Suburban Rail Loop East Precincts Standing Advisory Committee Volume 4: Box Hill Precinct

Advisory Committee Report

20 February 2026

Figure 4 **Distribution of height with Barnes' Areas 1 to 6**

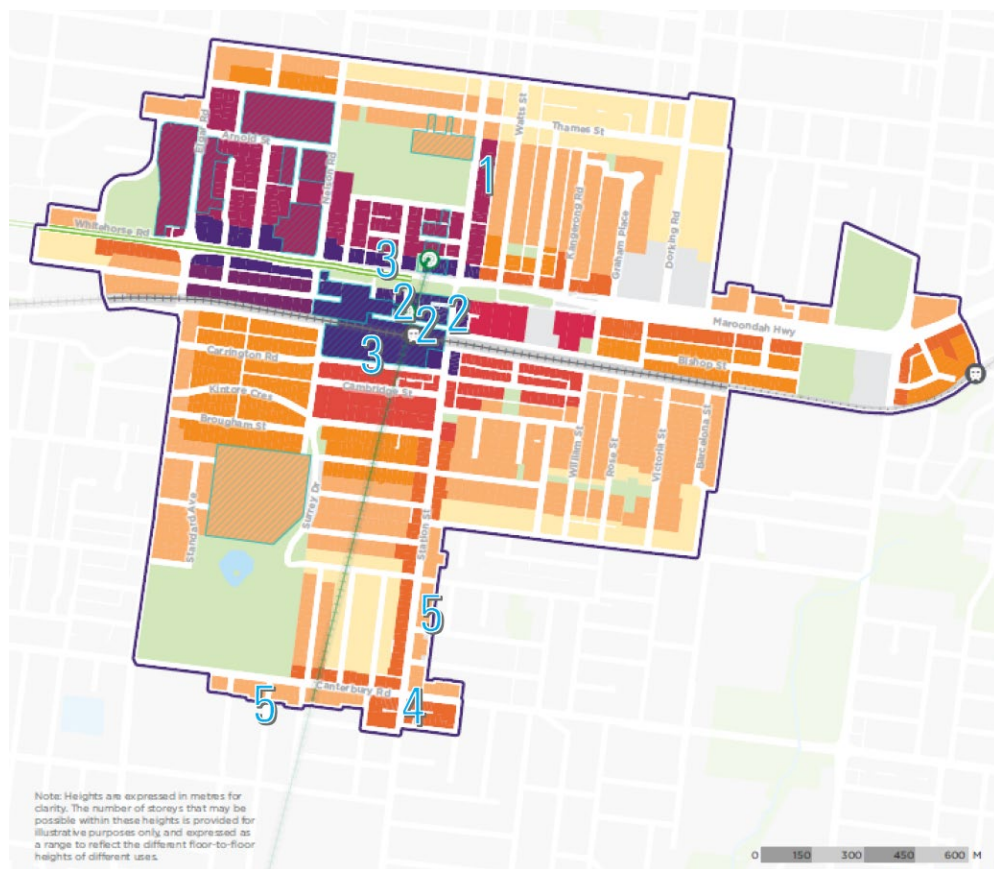
Specifically, Mr Barnes considered the heights in Areas 1, 4 and 5 (see Figure 4 for Mr Barnes' area locations) to be excessive. He recommended that, subject to urban design input, the heights in Area 1 be reduced from 52 to 27 metres, and in Areas 4 and 5 from 21 to 14 metres.

Mr Sheppard supported the building height transitions and did not agree with Mr Barnes' recommendations. For Area 1, he recommended BFO6 include the landscaping setbacks found at Clause 7.12 in other Central Flank BFO schedules. He considered that this change, along with the proposed six metre rear setback and rear laneway, would provide an adequate transition from the 52 metre heights on Station Street to the 21-metre residential zone.

Council's primary concern was moderating transitions from taller built forms to residential areas, reflecting the views of Mr Barnes and Mr Partos. It supported Mr Barnes' recommendations for reduced heights in Areas 4 and 5, considering these adjustments necessary to maintain residential amenity at the edge of the Structure Plan Area, as well as Prof McGauran's recommendations regarding Area 1, as discussed in Chapter 5.5. Council also emphasised the need for consistent interface treatments along Severn Street.
